City of Portland, Maine – Building or Use Permit Application 389 Congress Street, 04101, Tel: (207) 874-8703, FAX: 874-8716

Location of Construction: Seven Dirigo St		Owner: Maade C Swenson	Phone: 773-5625	Permit No: 970557
Owner Address: Seven Dirigo St- Portland ME 04102		Lessee/Buyer's Name:	Phone:	<div style="border: 2px solid black; padding: 5px; text-align: center;"> PERMIT ISSUED JUN - 9 1997 CITY OF PORTLAND </div>
Contractor Name: 02000		Address:	Phone:	
Past Use: l-fan dwlg	Proposed Use: l-fan w deck	COST OF WORK: \$ 2500	PERMIT FEE: \$ 35	Zone: CBL R-3 188--B-010-001 Zoning Approval: <i>[Signature]</i> Special Zone or Reviews: <input type="checkbox"/> Shoreland <input type="checkbox"/> Wetland <input type="checkbox"/> Flood Zone <input type="checkbox"/> Subdivision <input type="checkbox"/> Site Plan maj <input type="checkbox"/> minor <input type="checkbox"/> mm <input type="checkbox"/>
		FIRE DEPT. <input type="checkbox"/> Approved <input type="checkbox"/> Denied	INSPECTION: Use Group: Type:	
Proposed Project Description: construct deck		PEDESTRIAN ACTIVITIES DISTRICT (P.A.D.) Action: Approved <input type="checkbox"/> Approved with Conditions: <input type="checkbox"/> D

7 DIRIGO STREET
PORTLAND, MAINE

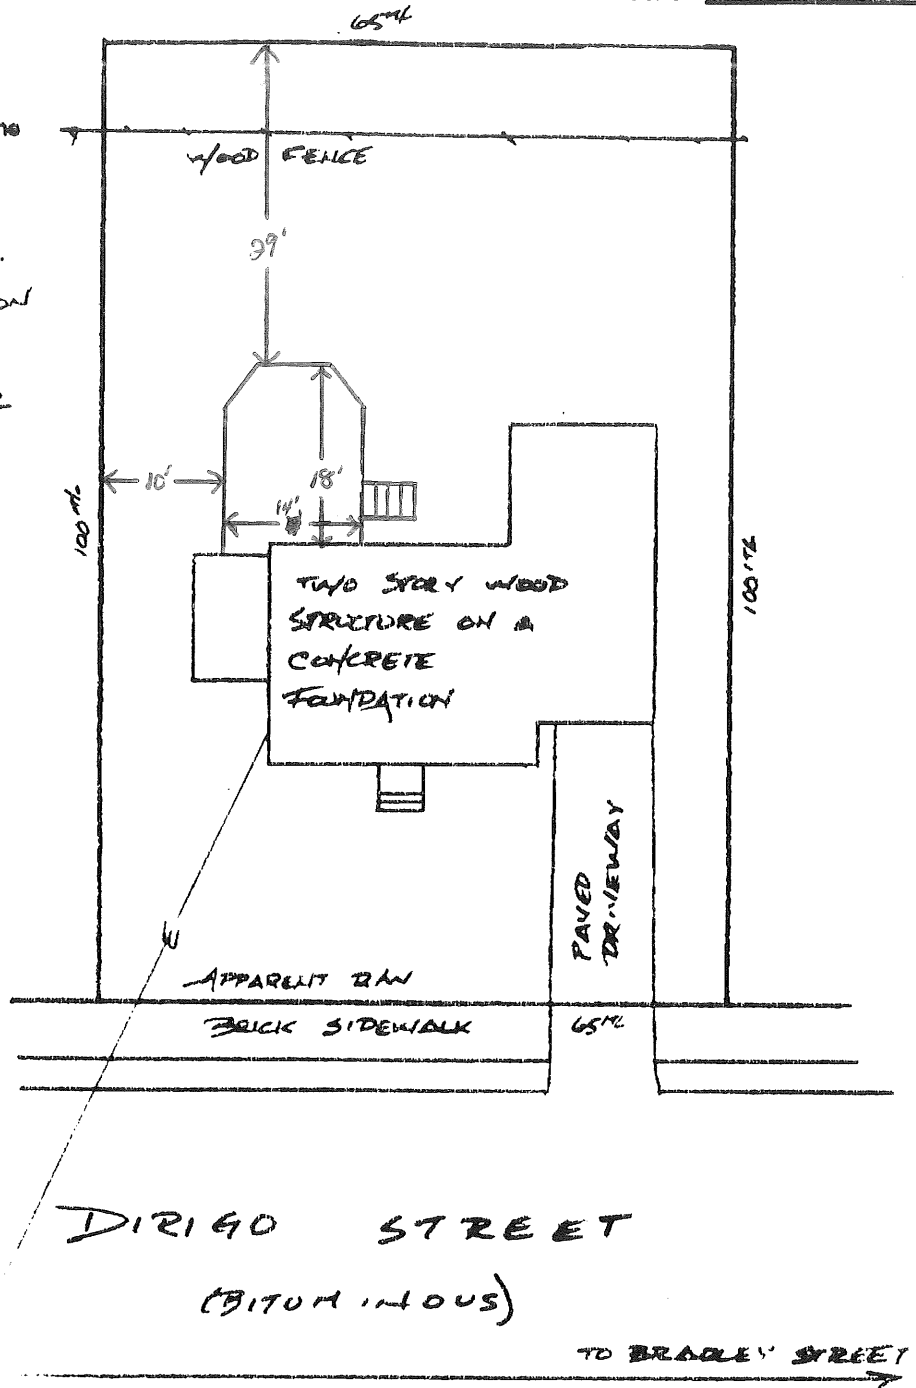
Proposed Use/Work - construct deck 14' x 18'

Front Yard - 25' req - 29' shown

Rear Yard - 8' req - 10' shown
